Planning Commission Staff Report

DATE: April 22, 2015

SUBJECT: REQUEST BY GANDO PROPERTIES FOR A MAJOR ARCHITECTURAL APPROVAL AND A VARIANCE APPLICATION TO CONSTRUCT AN APPROXIMATELY 96,445-SQ. FT. OFFICE SPACE, WAREHOUSE AND SELF STORAGE FACILITY ON AN APPROXIMATELY 4.5-ACRE PARCEL LOCATED AT THE SOUTH EAST CORNER OF GENE AUTRY TRAIL & TACHEVAH DRIVE, ZONE M-1-P, (3.3830-MAJ & 6.542-VAR) (ER).

SITE PLAN

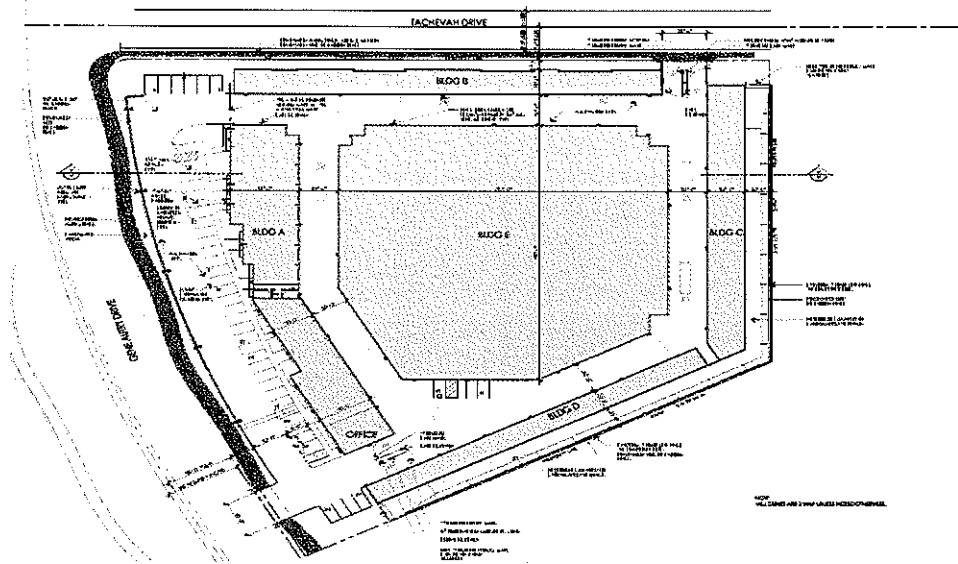
- Building B along Tachevah Drive does not conform to side yard setback.
- Building C on the easterly side does not conform to rear yard setback.
- Building D on the southerly side does not conform to side yard setback.

To mitigate the effect of reduced setbacks along the easterly and southerly portions of the project, a condition of approval (PLN 10) has been added to the set of conditions for the project. PLN 10 will require the applicant to plant additional trees at 30 feet on center behind Buildings C & D to serve as buffers between the storage buildings and the adjacent Escena Residential Development. Findings in support of the variance requests can be found in the required findings section of this report.

That the Planning Commission grants the variance request and approve the major architectural application as recommended by staff and the AAC.

BLDG. A ENLARGED WEST ELEVATION (NORTH PORTION)

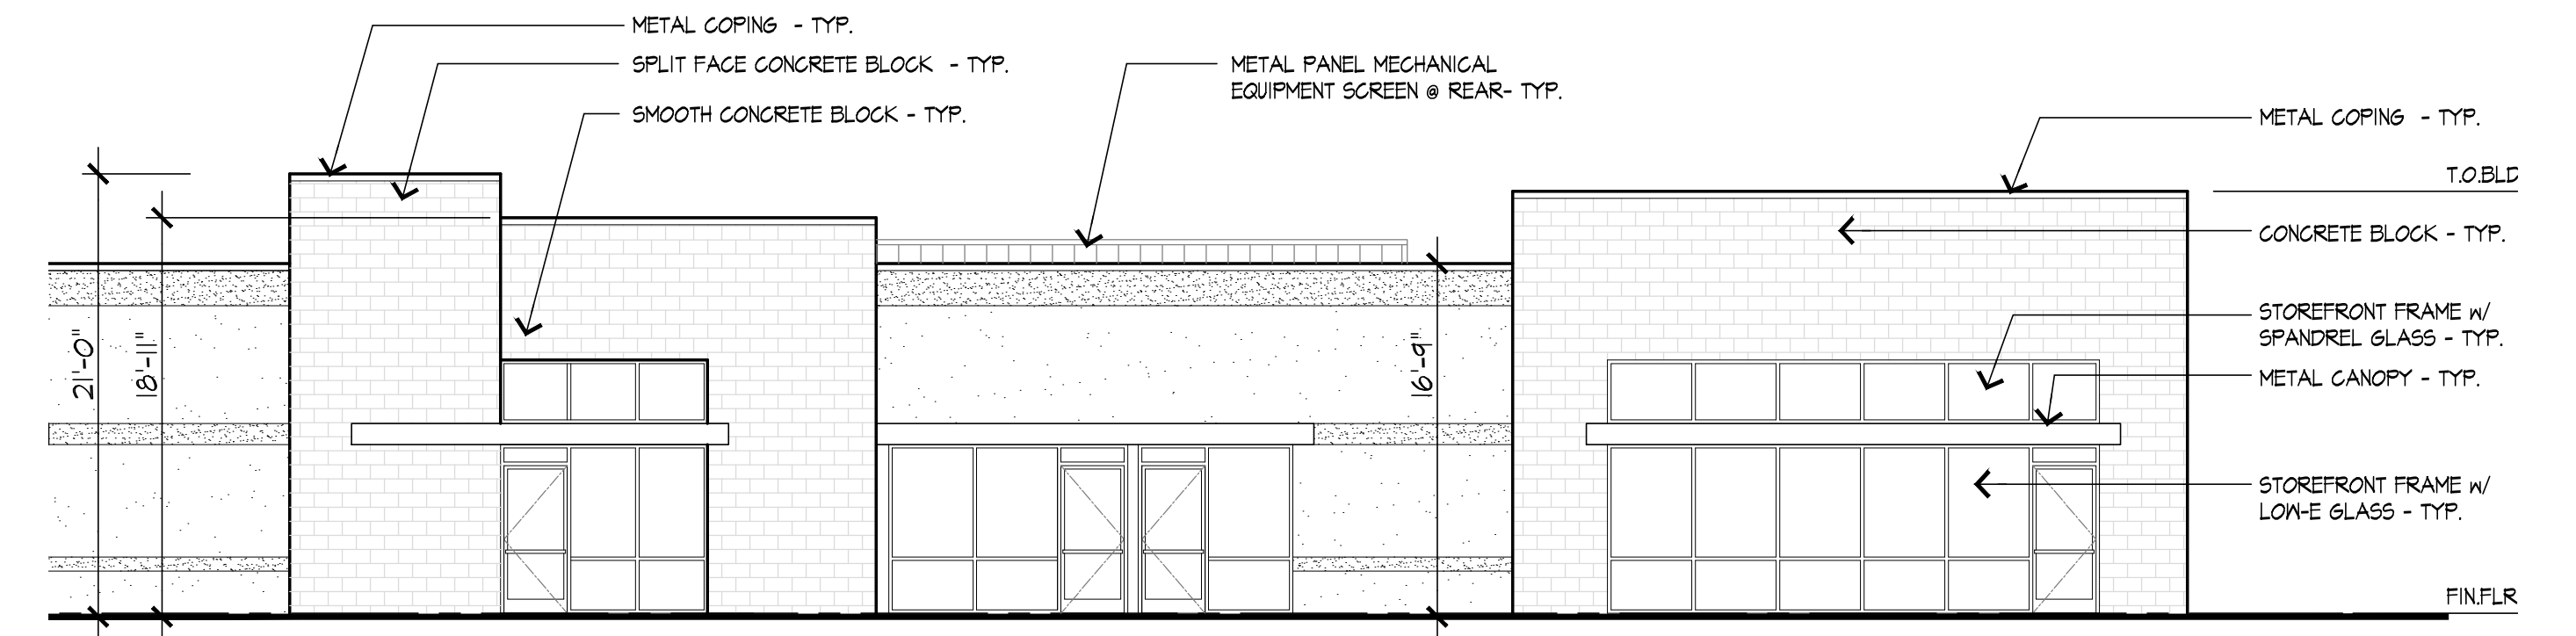
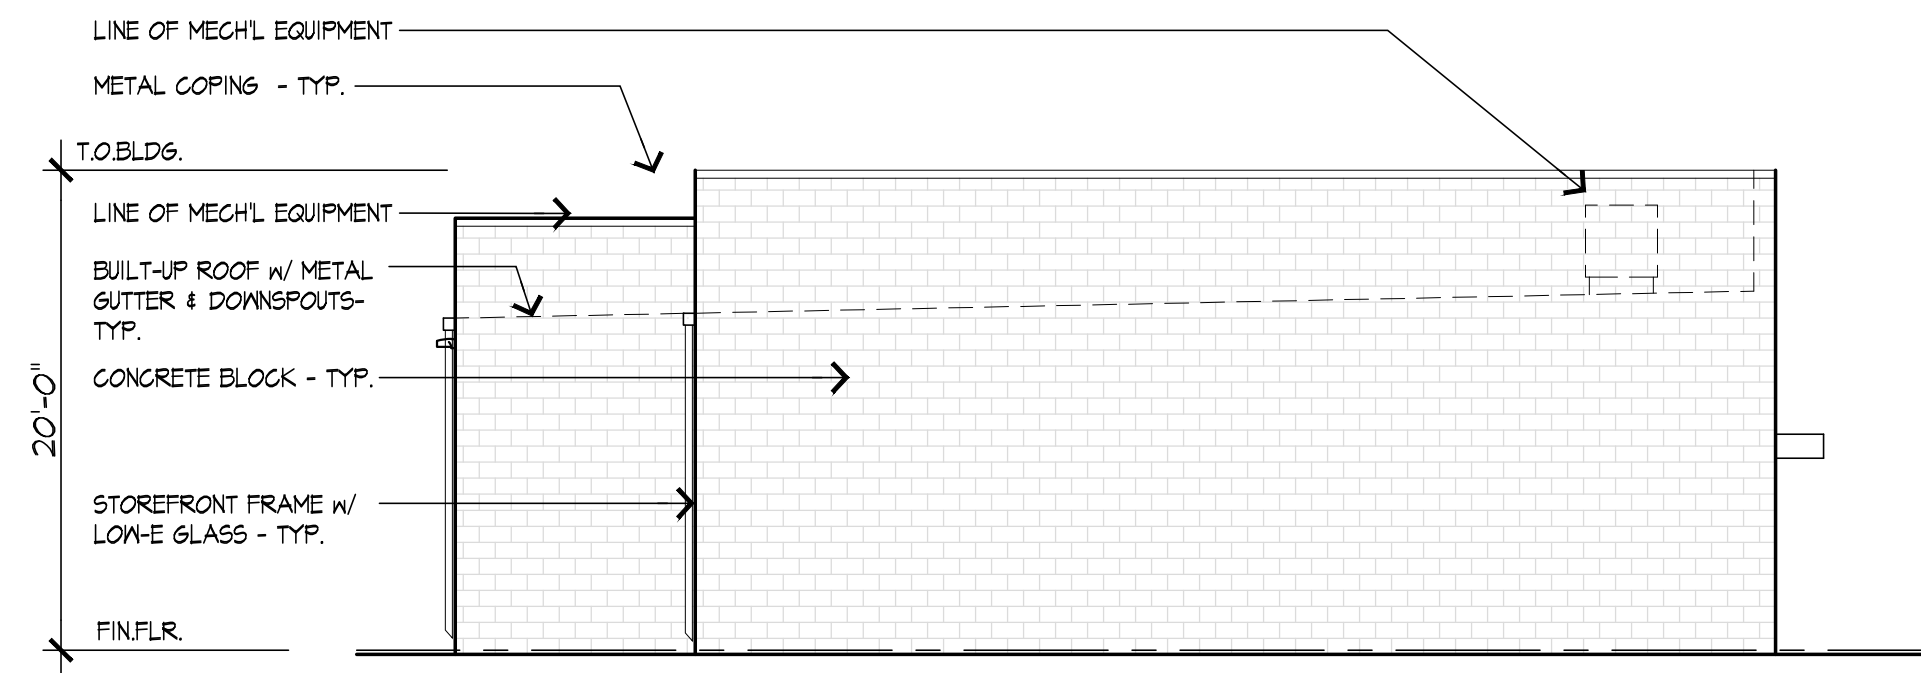
Member Song questioned the shaping of the west elevation of Building A and height of canopy. She questioned the difference between façade of buildings A & B.
